UNITED STATES PATENT AND TRADEMARK OFFICE

APPLICATION NO.	FILING DATE	FIRST NAMED INVENTOR	ATTORNEY DOCKET NO.	CONFIRMATION NO.
10/812,108	03/29/2004	Robert Lee Donovan	BA/Div App	1513

Office Action Summary

DETAILED ACTION

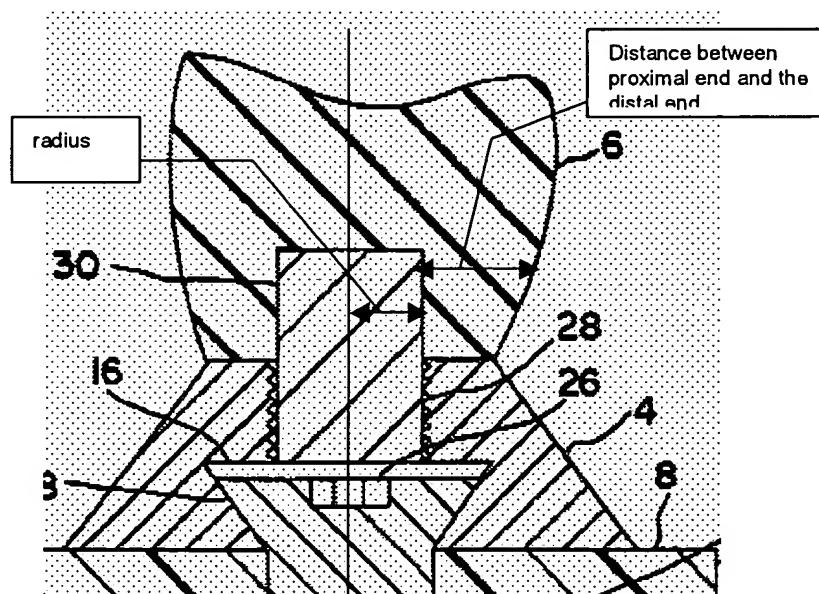
having a cylindrical, ring shaped base with an inner cylindrical ring surface, and an axis along the length of the cylindrical ring shaped base and a radius from the axis to the inner cylindrical ring surface as labeled in the marked up copy of figure 3 on this page, the damper further comprising a plurality of fins shown in the area of the lead line of number 6 shown in figure 2 extending from the ring shaped base in a radial direction from the axis, wherein each of the plurality of radial fins has a fin base at a proximal end of the fin at the ring base and a fin tip at a distal end of the fin, and wherein the radial fins are not constrained and are free to vibrate and wherein the distance between the proximal end and the distal end of the fins is at least as great as the radius as shown in the marked-up copy of figure 3 below, and wherein the inner cylindrical ring surface fits over the cylindrical projection or portion 30 of the cylindrical projection of the archery bow.
